ICC A117.1 Comments on 1st Draft

Proposal list to the 2017 A117.1 for the 2023 edition –
9-12-2024
Chapter 7 to 11

CHAPTER 7 COMMUNICATION ELEMENTS AND FEATURES

703.3 Raised characters.

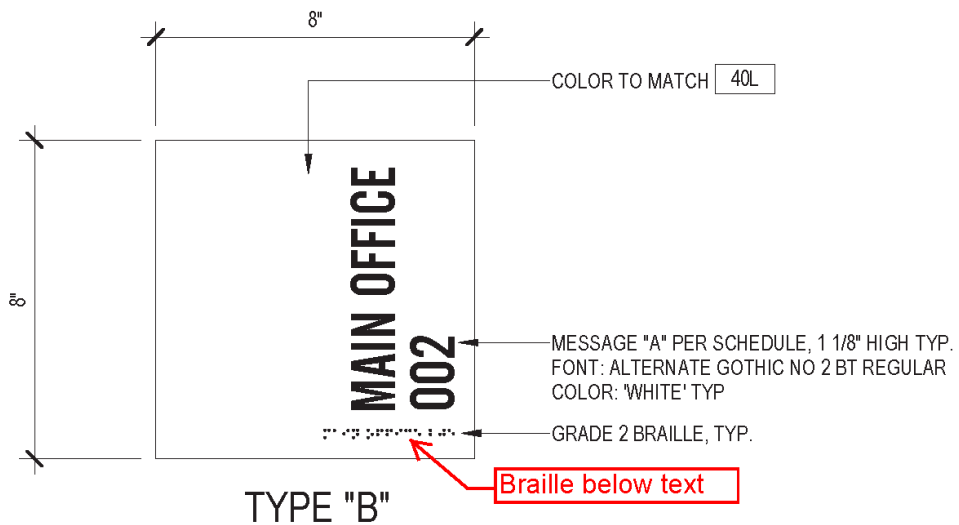
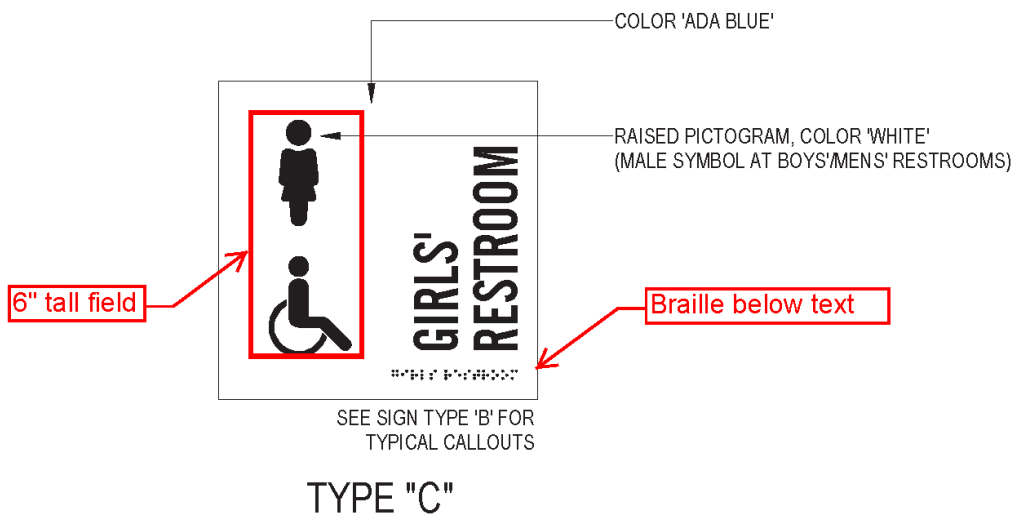
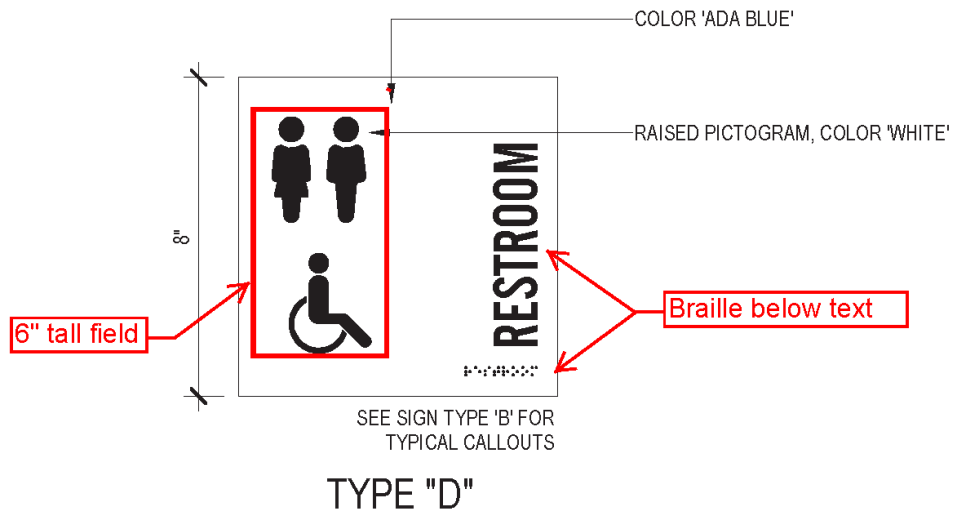
REASON: The standard does not currently provide any guidance regarding the orientation of either visual or raised characters. We have received several questions regarding whether the standard allows visual characters to be displayed in a vertical line. See the attached image as an example of a sign that was proposed to illustrate the issue that is trying to be addressed by this change.

This is an attempt to clarify an issue which is currently unaddressed within the standard. Where a sign is numbers only, there is nothing within the current text that says the numbers cannot be one under another instead of being placed horizontally in a row. However, although not stated, they

703.3.5 Text orientation: Raised characters shall be displayed in a horizontal orientation.

703.4 Braille

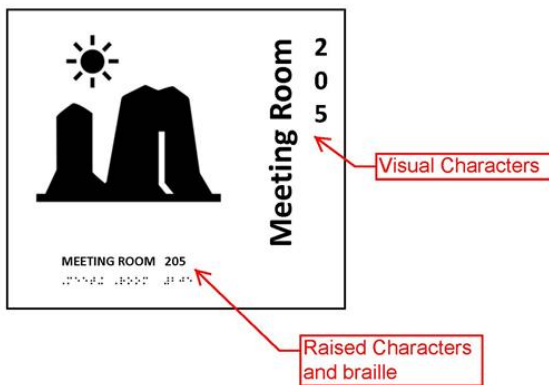
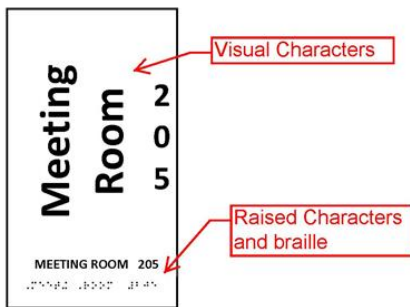
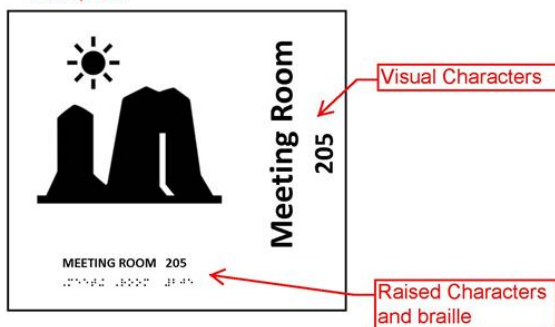
Reason: The reason in the original proposal did not show compliant examples, just the issue of signage. There were also concerns that the information for the braille should also include the horizontal requirement. The examples below are compliant examples.

703.4.4 Position. Braille shall be below the corresponding text and displayed in a horizontal orientation. If text is multilined, braille shall be placed below entire text. Braille shall be separated $\frac{3}{8}$ inch (9.5 mm) minimum from any other raised characters and $\frac{3}{8}$ inch (9.5 mm) minimum from raised borders and decorative elements. Braille provided on elevator car controls shall be separated $\frac{3}{16}$ inch (4.8 mm) minimum either directly below or adjacent to the corresponding raised characters or symbols.

Fig. 1. Back Wall Elevation

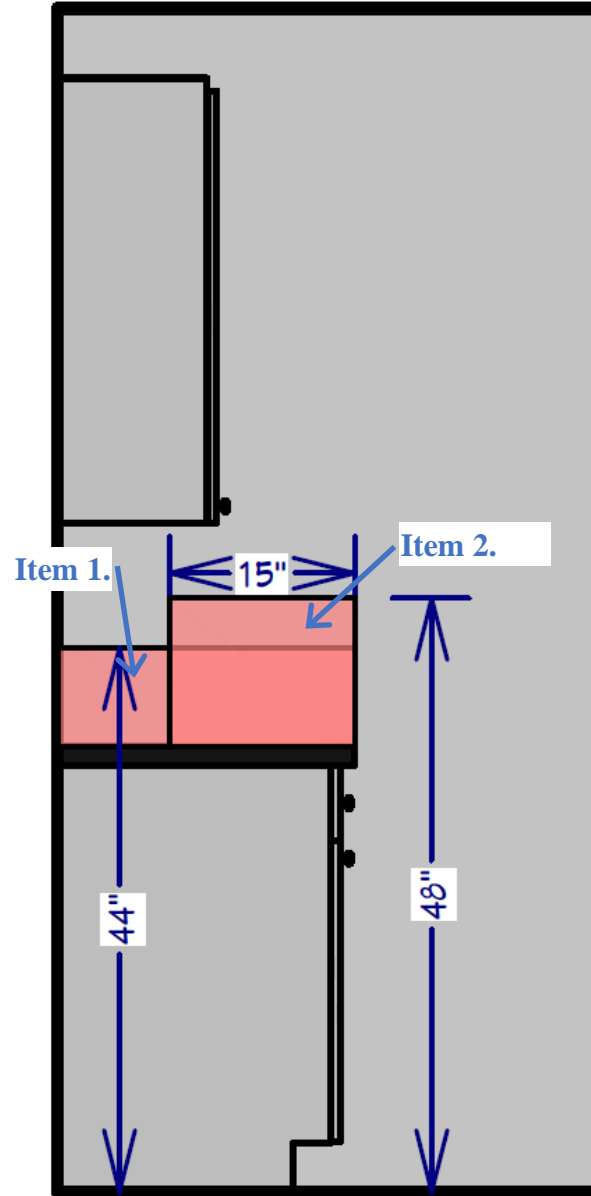
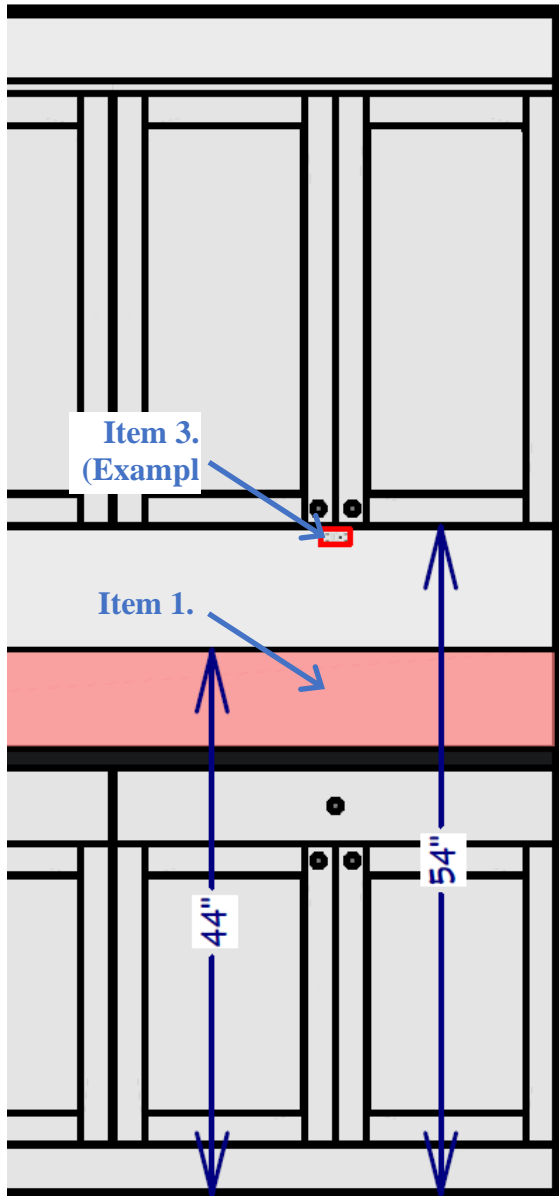
If all items in the list are adopted, this change would allow four options for receptacle outlets serving kitchen counters in Type A units once the requirement for two accessible receptacle outlets is satisfied: (1) install them at 44 inches maximum above the floor, (2) install them on a side wall at the end of a counter run 15 inches maximum from the front of the counter edge at 48 inches maximum above the floor, (3) install them at the face of the upper cabinets no more than 15 inches from the front counter edge and 54 inches maximum above the floor, or (4) fully comply with the general reach range and clear floor space requirements of the standard. (See Figures 1. and 2. below.)

FIGURE 1104.9
REACH OVER A KITCHEN OR BATHROOM CABINET

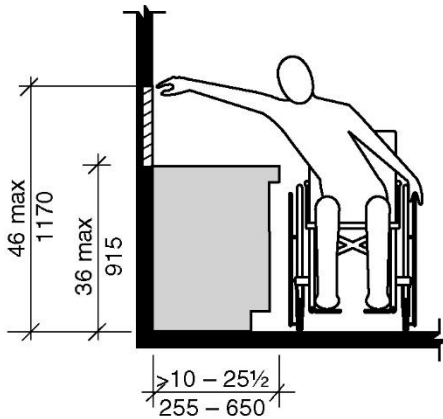
Reason: The proposed change affects kitchens in Type B dwelling units or sleeping units. The standard should clarify whether appliance protrusions, such as range and refrigerator protrusions, can be ignored for purposes of complying with the limitations for side reach over kitchen counters. Standard appliances such as ranges and refrigerators protrude beyond the face of the countertop several inches. In typical kitchen arrangements, there are commonly sections of countertop between these appliances, or between these appliances and other elements, where a parallel clear floor space cannot be positioned directly adjacent to the countertop due to an appliance protrusion. This issue does not only occur at “inside corners,” but also commonly occurs at linear kitchens with less than 48” between appliance protrusions.

10. Where redundant controls other than light switches are provided for a single element, one control in each space shall not be required to comply with this section.
11. Within kitchens and bathrooms, lighting controls, electrical switches and receptacle outlets are permitted to be located over cabinets with countertops 36 inches (915 mm) maximum in height and 25 1/2 inches (650 mm) maximum in depth. Freestanding or slide-in kitchen appliances are not considered to impact the reach depth to receptacle outlets, switches or controls over the countertop.

Fig. 1. Back Wall Elevation

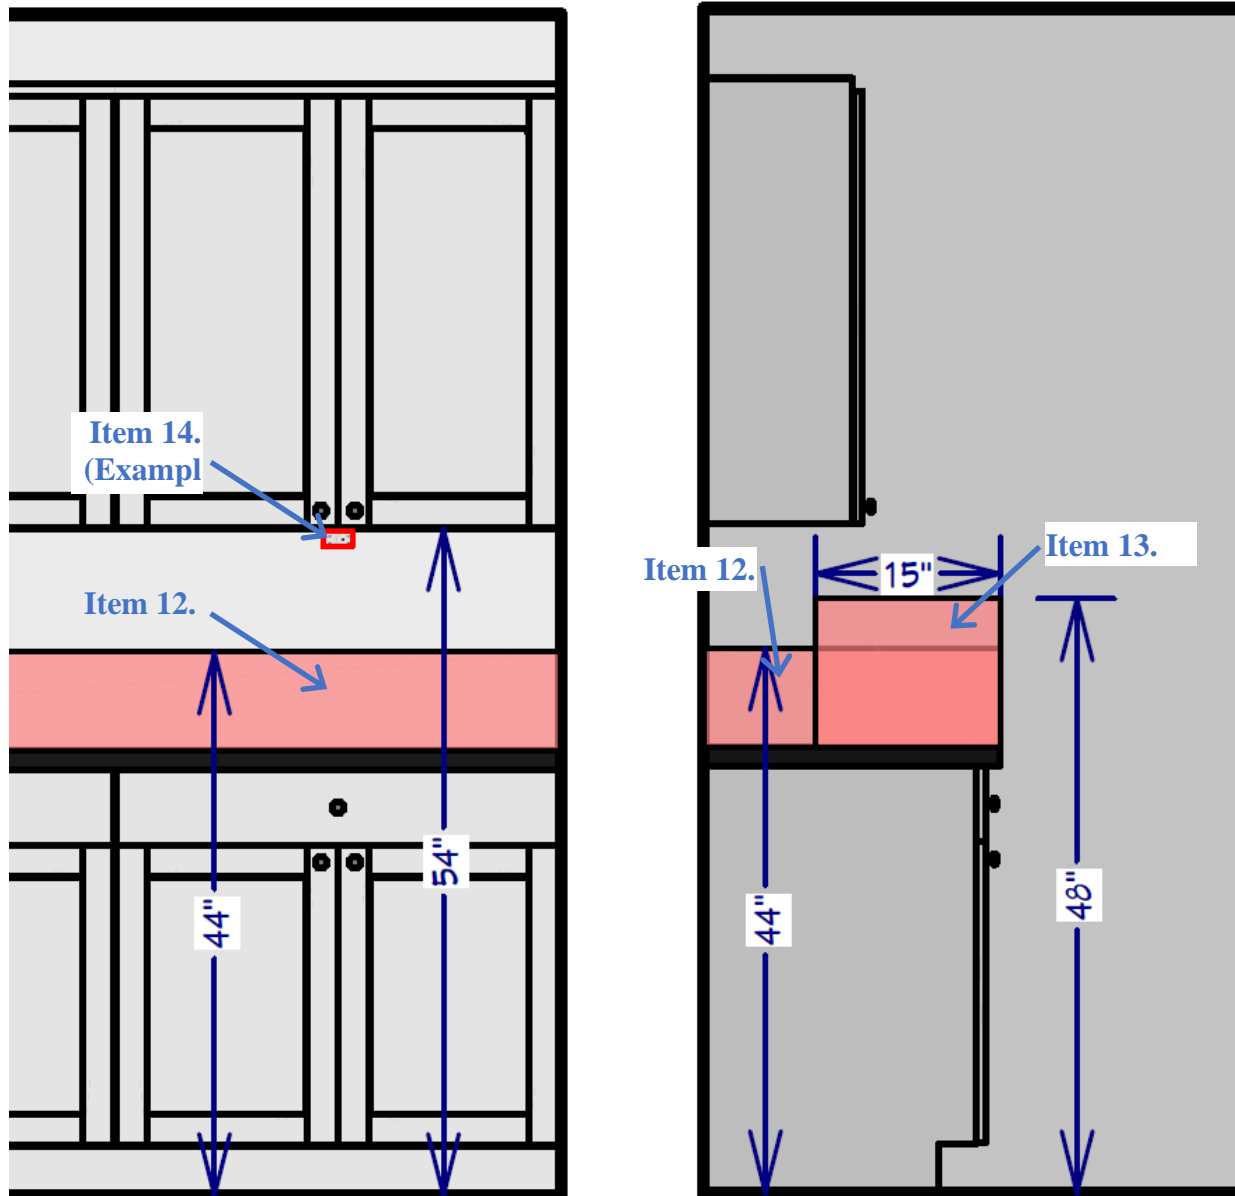
If all items in the list are adopted, this change would allow four options for receptacle outlets serving kitchen counters in Type B units: (1) install them at 44 inches maximum above the floor, (2) install them on a side wall at the end of a counter run 15 inches maximum from the front of the counter edge at 48 inches maximum above the floor, (3) install them at the face of the upper cabinets no more than 15 inches from the front counter edge and 54 inches maximum above the floor, or (4) fully comply with the general reach range and clear floor space requirements of the standard. (See Figures 1. and 2. below.)

**FIGURE 1104.11.3.1.1
LAVATORY IN TYPE B UNITS – OPTION A BATHROOMS**

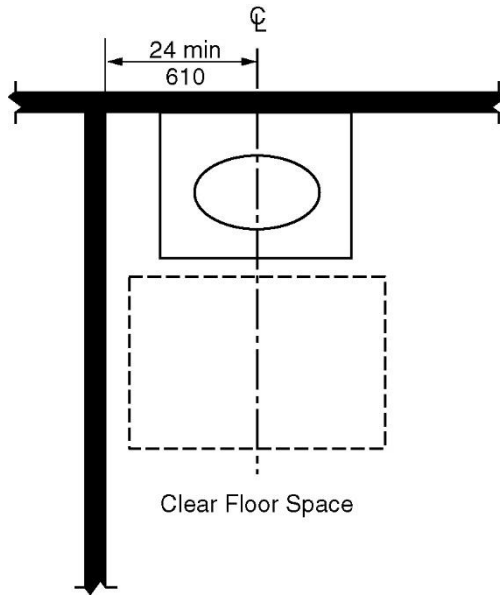
REASON: The original intent of the committee for the exception was to allow for a front approach lavatory without adding the larger clear floor space size. By not including the reference to Section 606.2 the current text does not address the front approach or the knee and toe clearance. This is Option A. Option B references this section so this is a glitch for both options in Type B units.

Exception: A lavatory complying with Section 606 ~~Sections 606.3, 606.4 and~~ except with a clear floor space complying with Section 1104.1.1 shall be permitted. Cabinetry shall be permitted under the lavatory provided the following criteria are met:

1. The cabinetry can be removed without removal or replacement of the lavatory, and
2. The floor finish extends under the cabinetry, and
3. The walls behind and surrounding the cabinetry are finished.

Figure 1104.11.3.1.3.2
Forward approach bathtubs in Type B units
Option A bathrooms

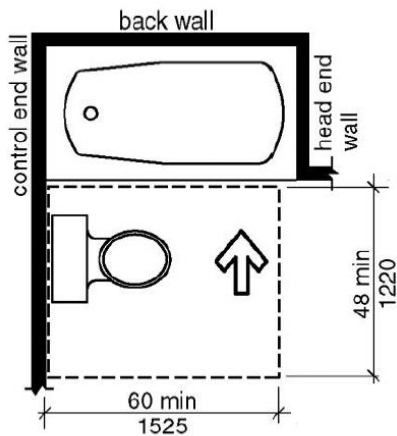
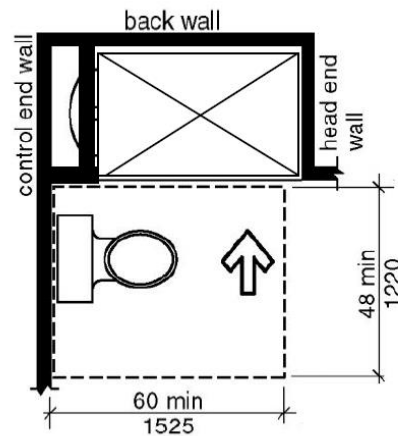
It is my interpretation that this is a safer and more accessible option. If a person in a wheelchair could approach a bathtub in this configuration, there is no reason that same approach could not be equivalent or better for a shower.

Below are what is currently permitted, and what is proposed.

Figure 1104.11.3.1.3.4
FORWARD APPROACH SHOWER COMPARTMENT IN TYPE B UNITS
(Note: Figure similar to this. I don't have access to new graphic at this time.)

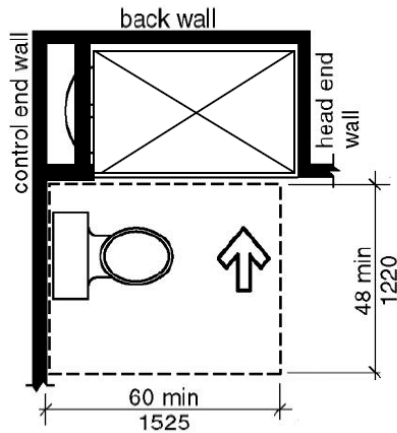
REASON: I had some people ask if someone installed this shower even with the water closet instead of as shown. I believe the text revision will address this concern. Measuring from the front of the water closet is not a good option, because the walls have to be in place way before the water closet is installed, and what you planned on is not always the one get gets installed. Please see the reason for the original proposal for what is permitted for tubs. We do not address smaller tubs, so this is actually a higher level of access for both clearance and not having to step over the edge of the tub.

1104.11.3.1.3.4 Forward approach Shower compartment. The shower compartment shall have dimensions of 30 inches (760 mm) minimum in depth and 44 inches (1120 mm) minimum in width. A clearance of 60 inches (1525 mm) minimum in length measured perpendicular from a side wall and 48 inches (1220 mm) minimum in width shall be provided in front of shower compartment with a forward approach. A water closet and a lavatory shall be permitted in the clearance at one side of the shower compartment opposite the side wall from which the clearance is measured.
